Risingtex Fashion Ltd.

Auchpara, Ashulia
(23.887955N, 90.297218E)
8th January 2019

Observations

Canteen Shed

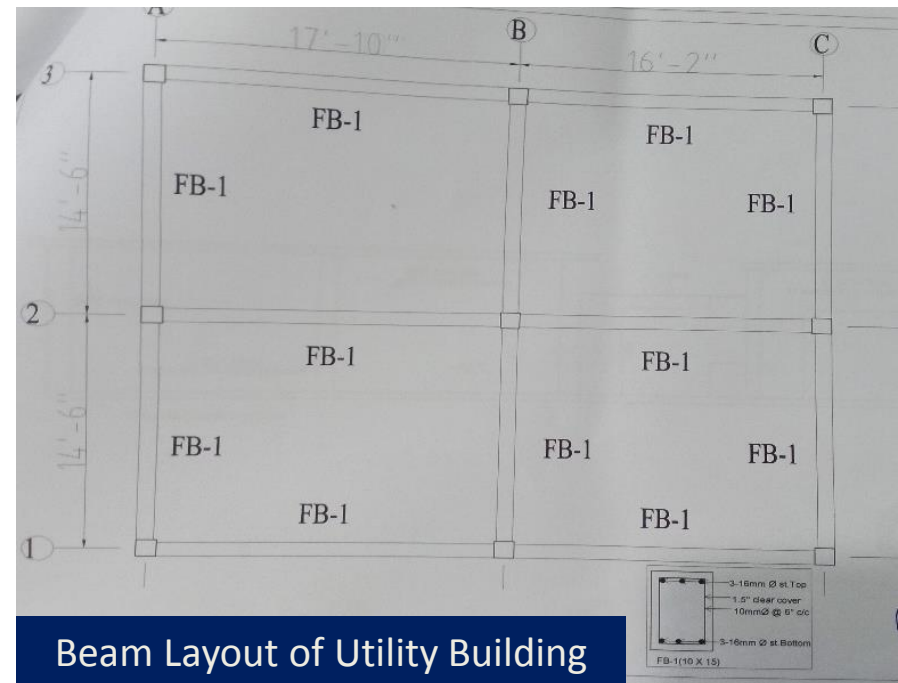
Channel sizes of rafter of canteen shed was found (100 x 50 x 4) mm instead of (75x37x5) mm.

Beam Layout of Utility Building

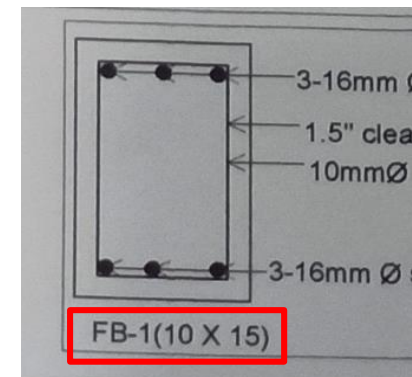
Beam sizes did not match with drawings of Utility Building. Depth of beam was found 250 mm (10 inches) instead of 375 mm (15 inches).
